Project	IEEE 802.16 Broadband Wireless Access Working Group <http: 16="" ieee802.org=""></http:>		
Title	Clarification of CQICH allocation request header		
Date Submitted	2005-03-17		
Source(s)	Yongseok Jin, Bin-Chul Ihm, Jin Young Chun	Voice: 82-31-450-7187 Fax: 82-31-450-7129	
	LG Electronics. Inc.	jayjay@lge.com	
	Jung Je Son	jungje.son@samsung.com	
	Samsung Electronics		
Re:	This is a contribution to IEEE 802.16e.		
Abstract	In the current document of 802.16e, i.e., 16e/D6, the type field code allocation is problematic, e.g., duplicated allocations. This contribution proposes to add tables to list the type fields encodings and also to clean up the type code allocation problems in 16e/D6.		
Purpose	To correct the errors of the type code allocations and also to improve the type code allocations.		
Notice	This document has been prepared to assist IEEE 802.16. It is offered as a basis for discussion and is not binding on the contributing individual(s) or organization(s). The material in this document is subject to change in form and content after further study. The contributor(s) reserve(s) the right to add, amend or withdraw material contained herein.

## **Clarification of CQICH

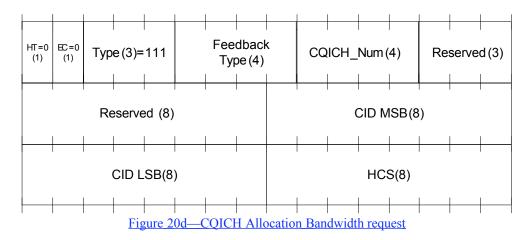
[Insert new sub clause 6.3.2.1.2.3:]

6.3.2.1.2.3 CQICH Allocation Request Header

The CQICH Allocation request PDU shall consist of CQICH Allocation request header alone and shall not contain a payload. The CQICH Allocation request header is illustrated in Figure 20d
